Re: Historic Preservation Report for
McIndoes Academy, Academy Lane, McIndoe Falls (Barnet), VT
Feasibility Study for Renovation & Adaptive Re-use Project

McIndoes Academy – Historic Preservation Letter, April 25, 2018

**Proposed First floor plans
(Arnold & Scangas Arch.)**

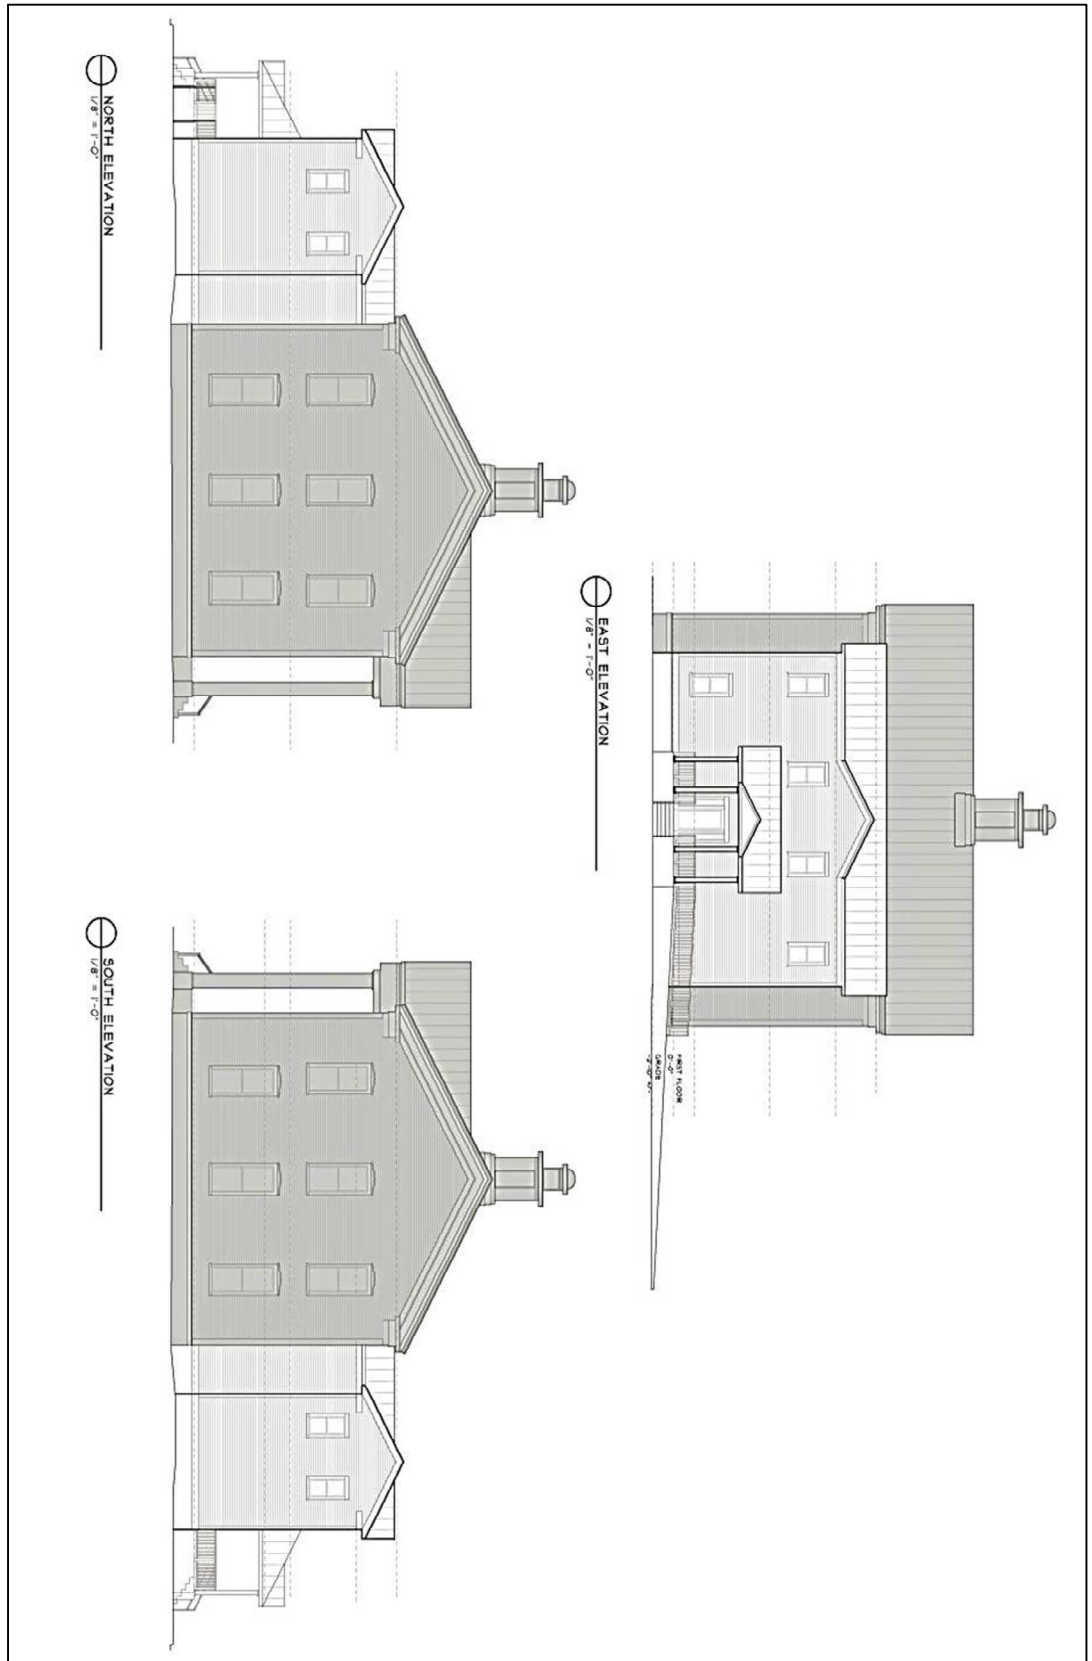
The proposed project will construct a compatible, two-story rear addition to achieve the program goals while preserving the existing historic character of the main building. The new addition will be narrower and slightly lower than the main building and set off of the main block by a hyphen connection that attaches to the center two bays while leaving the outer two bays untouched. The addition will provide a vault, restrooms, elevator and fire stair as well as a new history room on the second floor. A new rear ramp will be built onto the new rear (east) elevation of the addition. The current rear ramp and metal fire escape will be removed and except for the two center rear window bays, the exterior of the historic main block will be preserved - repaired, and painted where needed. The historic windows will be refurbished and new storm windows applied.

On the first floor, two of the present three restrooms will be removed from the main block and the northwest first floor room will be restored to its original dimensions. Previously altered first floor spaces will be re-configured to provide offices and a front to back hallway without impacting any windows. The front stair hall floor plan will be essentially unchanged though the modern finishes may be removed. The present post office will not be altered. Elsewhere, the dropped ceilings will be removed and full height restored. One rear window will be removed for the vault and one infilled.

On the second floor the southwest museum room will remain unchanged. The main room will also remain intact as a large meeting space but a centered door will be located on the east wall

and two windows will be infilled. In addition, the original roof trusses that support the large open span will be repaired and the modern posts removed. The northwest room will expand a bit into the adjacent small vestibule and capture the space of the stage area closet as well. The appearance of the original vestibule door from the main room will be unchanged. The stage area will only change in that the closet wall will extend forward and be solid.

This proposed project does a good job of providing additional program space and code compliance through a sensitive new addition, well located to the rear, while preserving and restoring the historic character of the main block. The attachment of the rear addition through a narrower hyphen allows two of the four window bays on the rear elevation to be preserved. Loss of the two center bays of windows seems a very reasonable trade-off for the level of preservation achieved. **I believe the proposed project meets the Secretary of the Interior’s Standards for Rehabilitation and will have no adverse effect on this historic building.**
